AUTOMATIC TRANSMISSION SERVICE GROUP

**REVISED EDITION**

Since the introduction of the THM 440-T4 Transaxle in April, 1984, there have been many major engineering design changes. These changes have affected nearly every part used in the THM 440-T4. This Update Handbook will explain each change, the parts affected by the change, and any parts interchangeability problems created by the change.

Figure 90

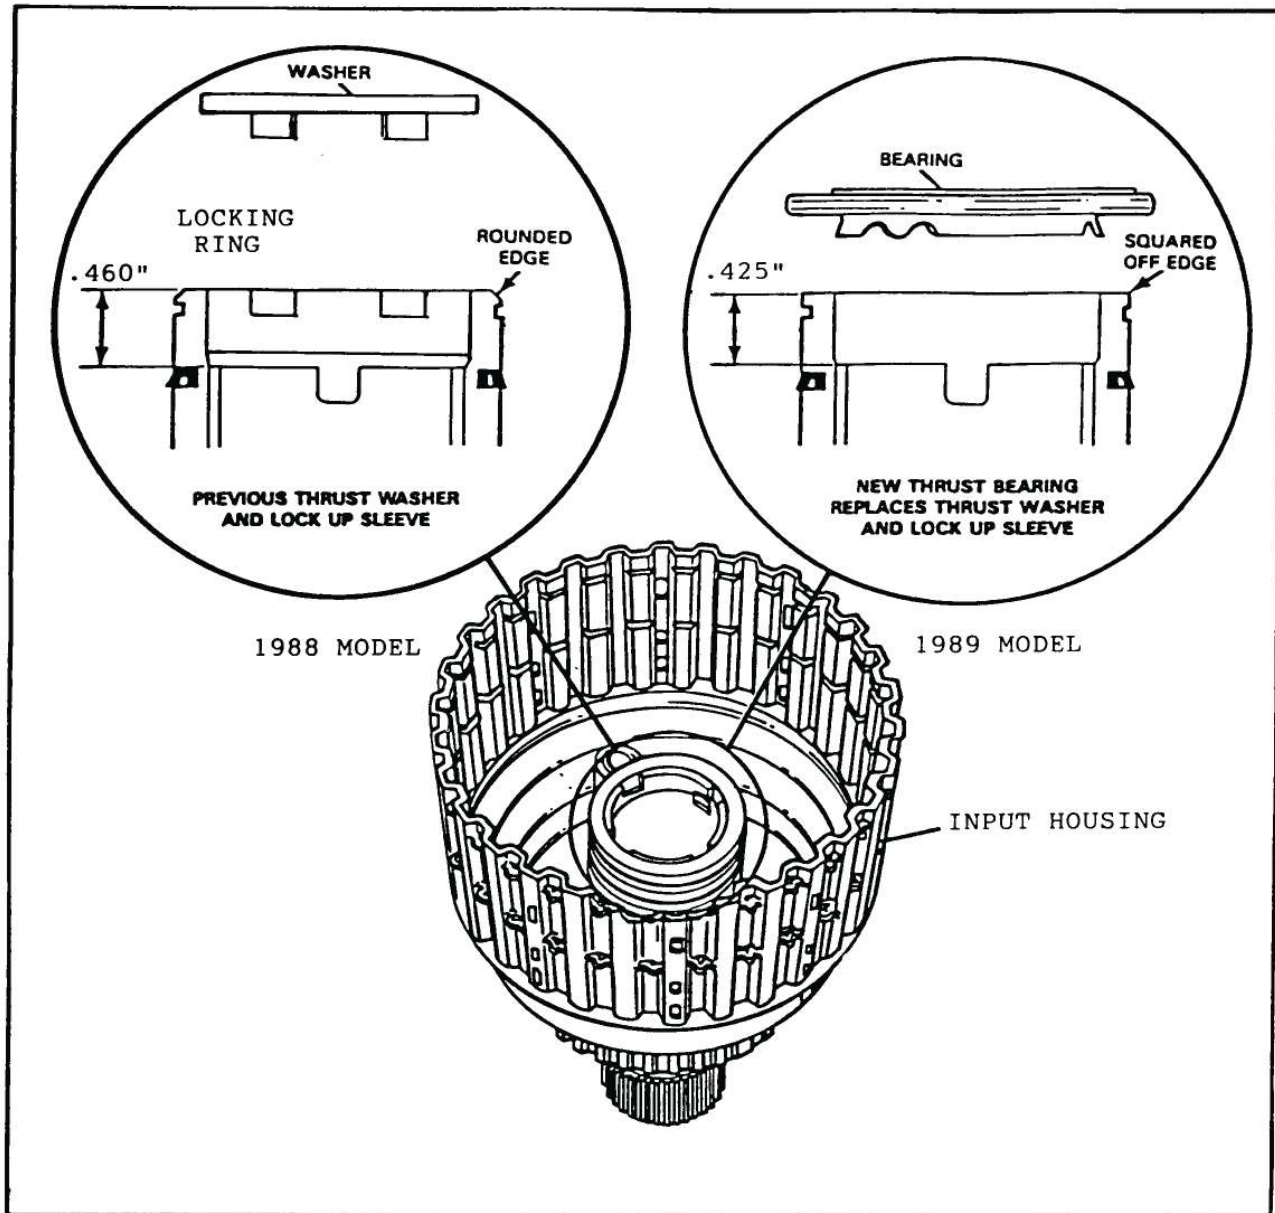
- (1) Input Housing - Surface on the input housing where the new bearing assembly rides, has been reduced by .035" to accommodate the increased thickness of the new bearing (See Figure 90).
- (2) "Top Hat" Thrust Washer - Eliminated (See Figure 90).
- (3) Lock Up Sleeve - The lock up sleeve is no longer needed and has been eliminated (See Figure 90).
- (4) 3rd Roller Clutch Lube Dam - The inside diameter has been increased by .256" to accommodate the larger diameter new bearing, and the lip on the lube dam eliminated for increased lube flow to the 3rd roller assembly (See Figure 91).
- (5) 3rd Roller Clutch Inner Race - Has been machined .040" thinner to accommodate the increased thickness of the new bearing assembly (See Figure 91).

Figure 92

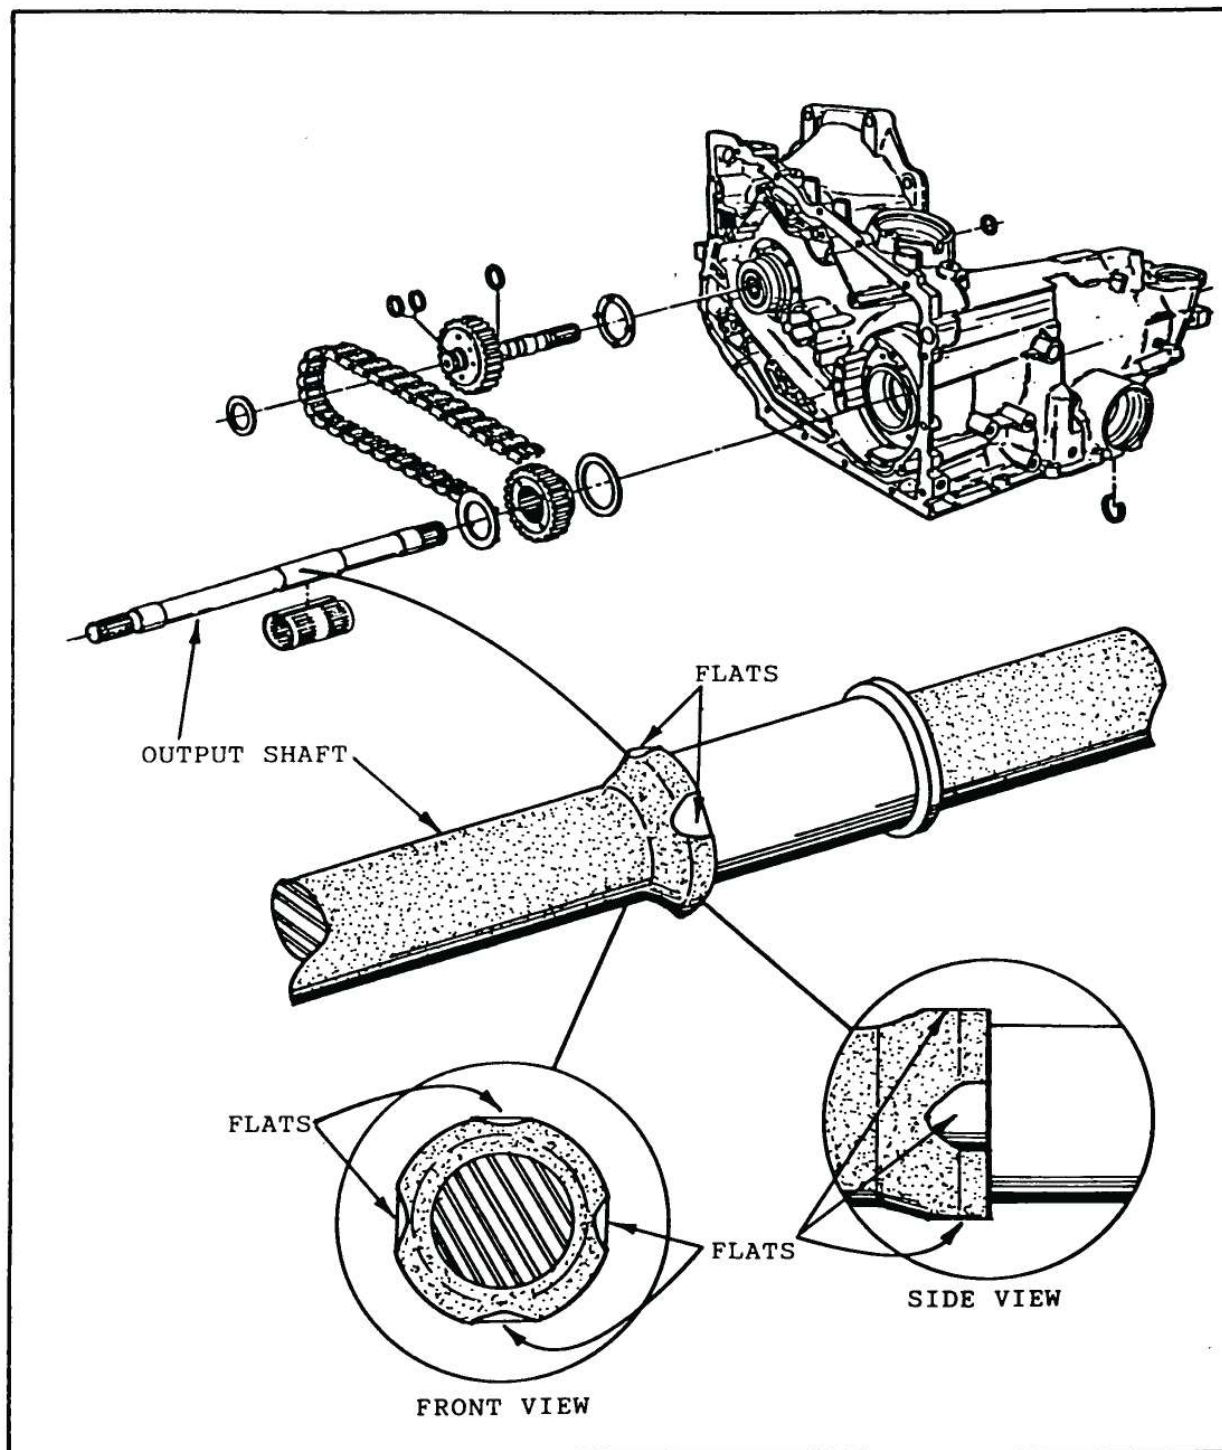
- CORRECTION:** Modification as follows, of the parts indicated, will increase lube flow to both the 3rd Roller Clutch and the Input Sprag.
1. **MODIFY OUTPUT SHAFT:**
Grind four (4) flats on the Output Shaft at the front of the bearing in the locations shown in Figure 92.

Figure 93

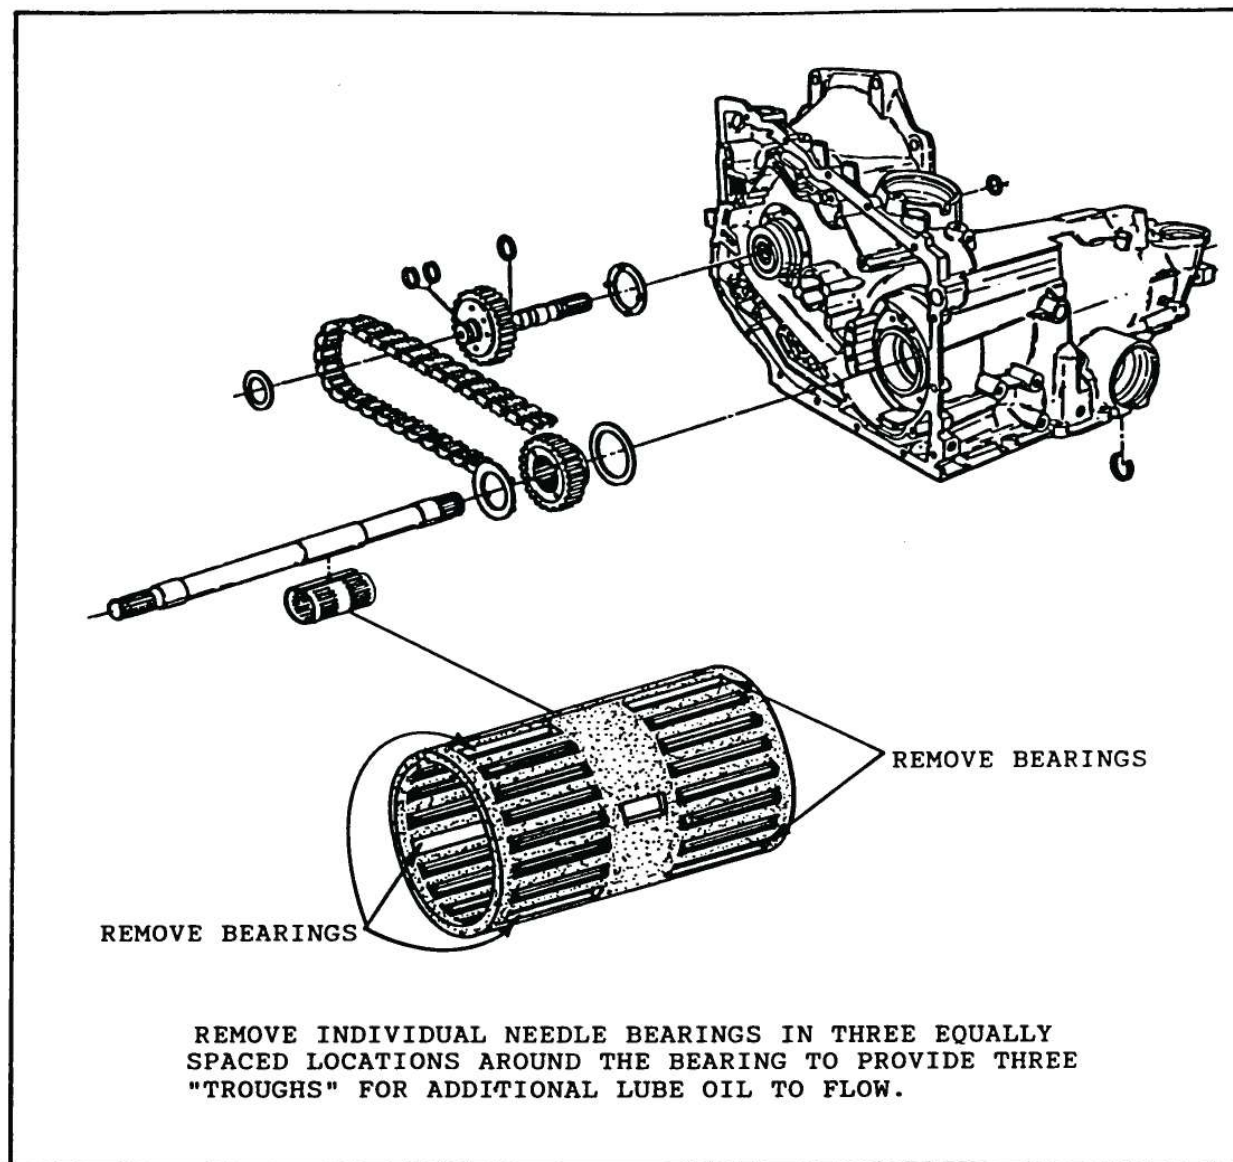
2. **MODIFY OUTPUT SHAFT BEARING:**
Remove individual needle bearings as shown in Figure 93 in three equally spaced locations around the bearing, to provide three "Troughs" for additional lube oil to flow. Removing the needles does not impair the durability of the bearing assembly.

Figure 94

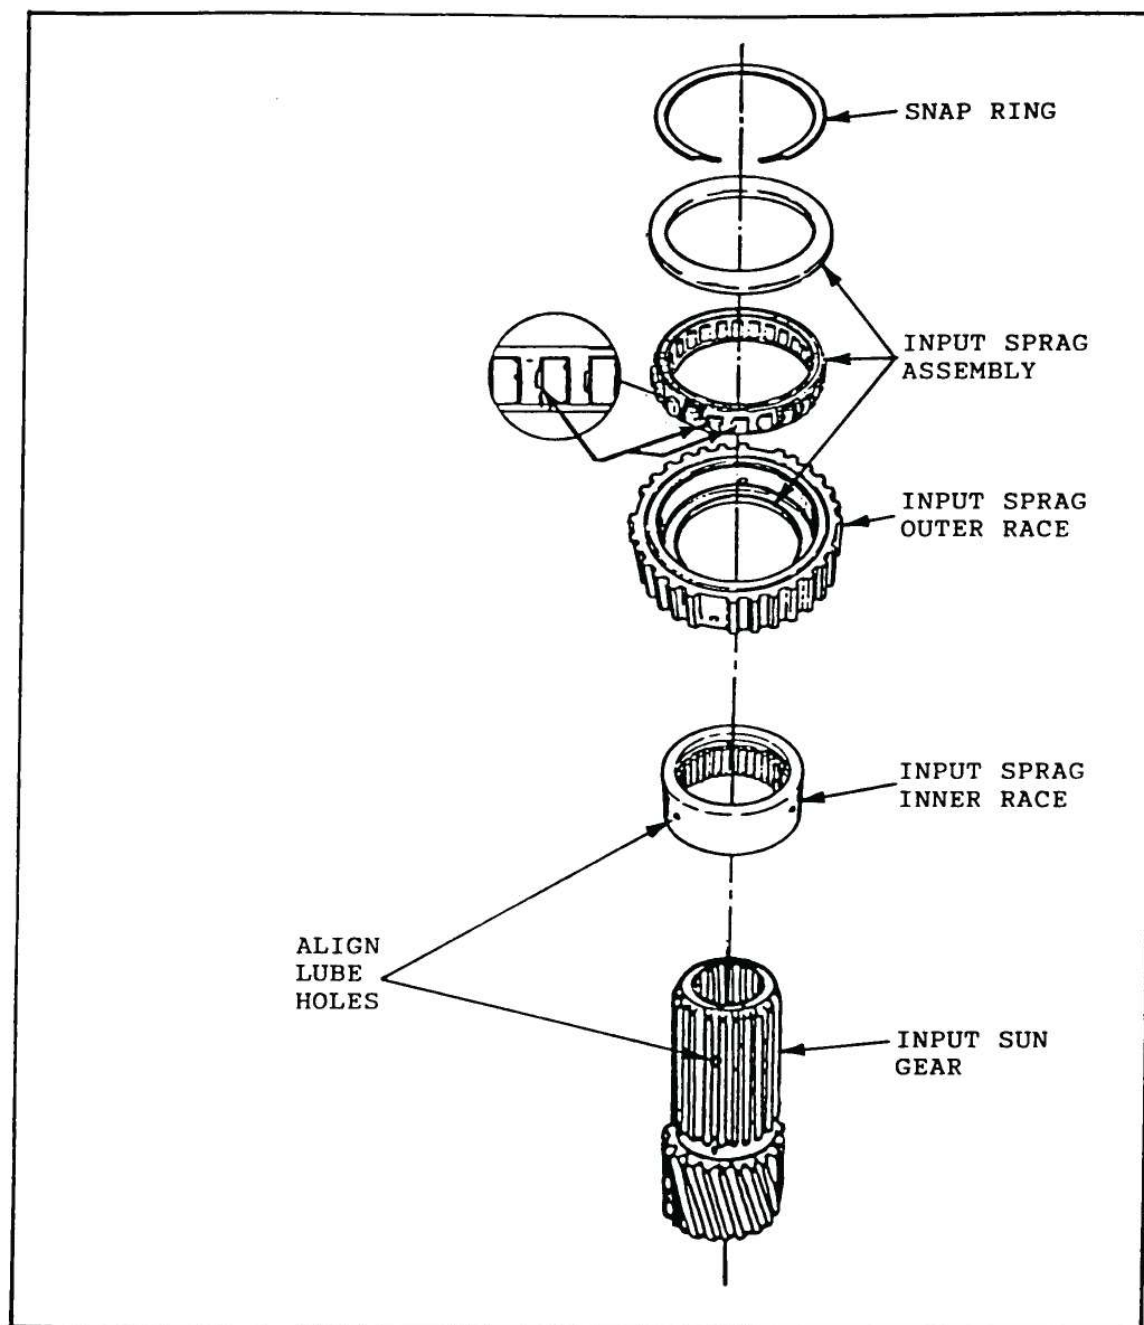
3. **MODIFY ASSEMBLY PROCEDURE:**
When installing the Sprag Assembly onto the Input Sun Gear, align one of the three lube oil holes in the inner race, with one of the two lube oil holes in the Input Sun Gear, as shown in Figure 94.

Figure 95

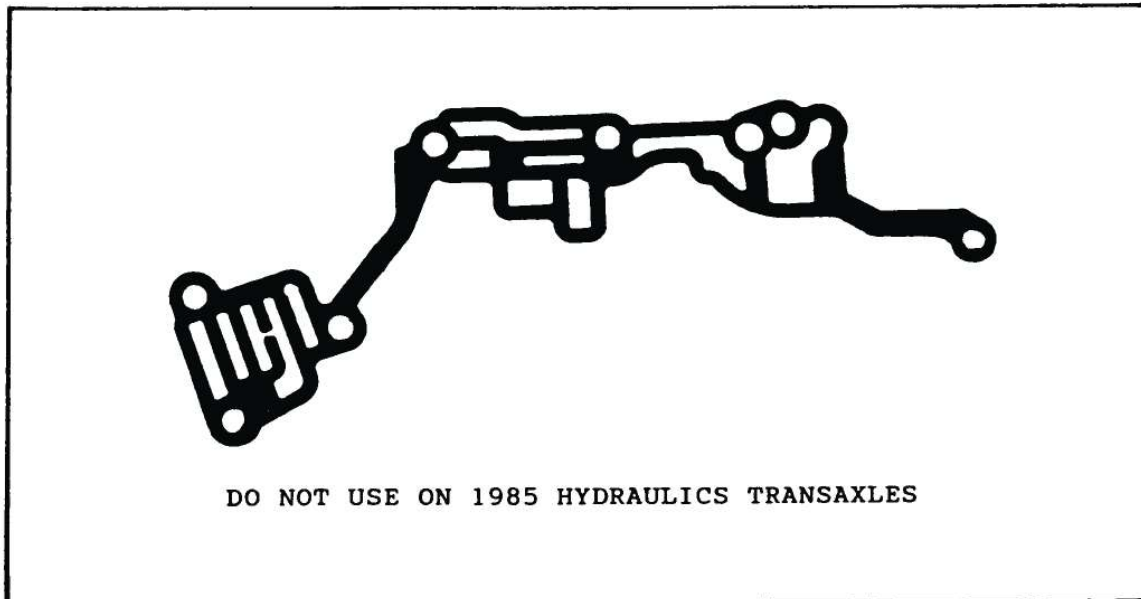
CHANGE: Upper Channel Plate Gasket (See Figure 95).

- (1) Upper Channel Plate Gasket - The Upper Channel Plate Gasket and Modulator Port Gasket are now connected together as one gasket (See Figure 95).

Figure 96

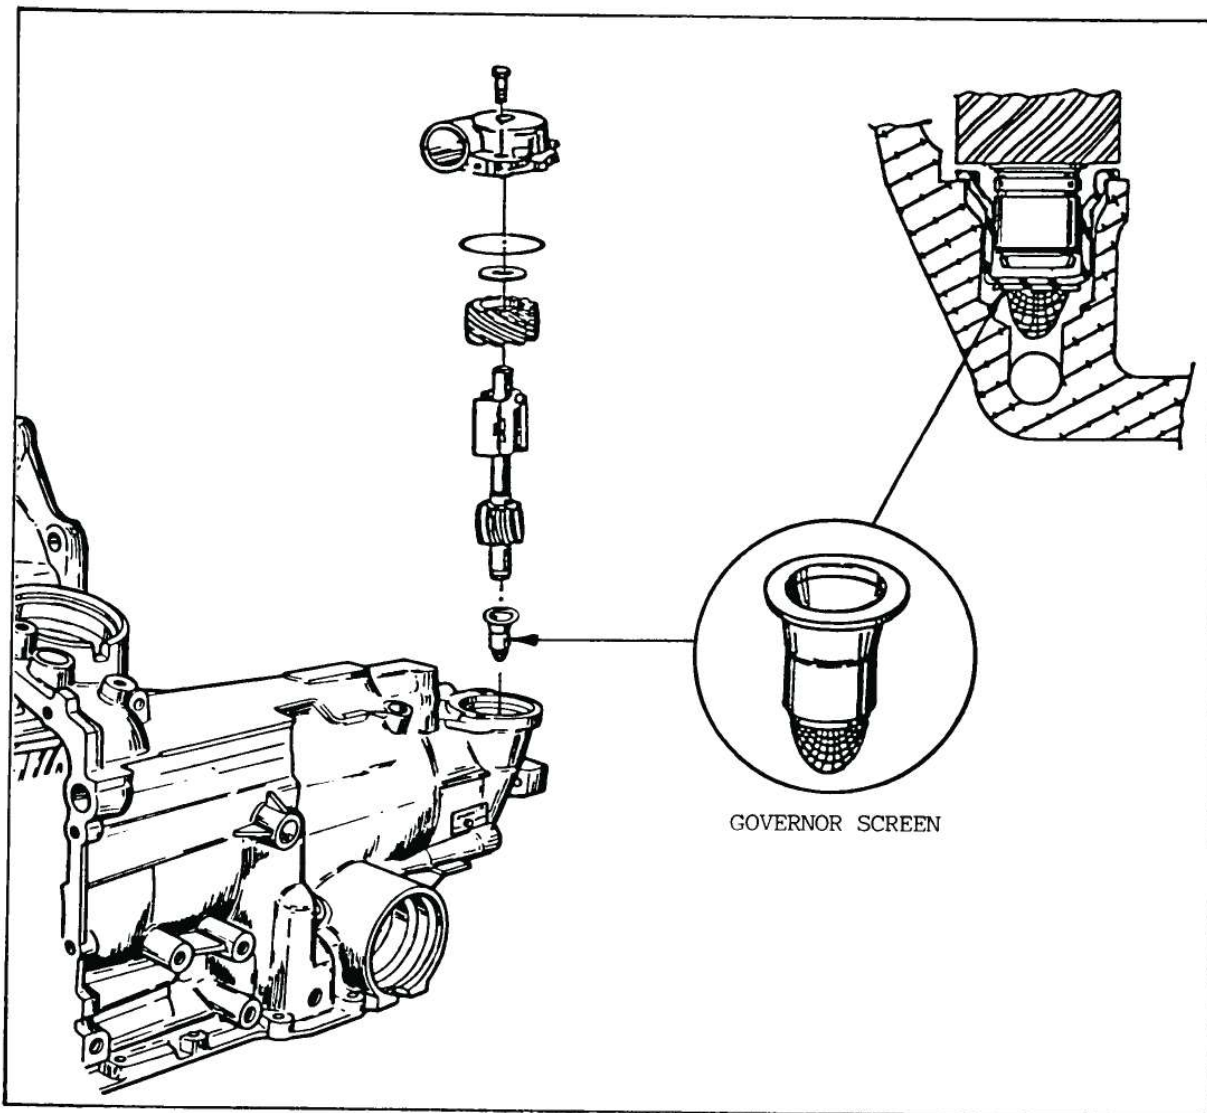
The governor screen was added in 1989 to the governor sleeve in the case, to minimize the possibility of sediment entering the governor assembly and preventing the governor balls from seating properly. (See Figure 96).

A machining change was necessary in the case to make room for the new governor screen, thus it will not retro fit to previous models.
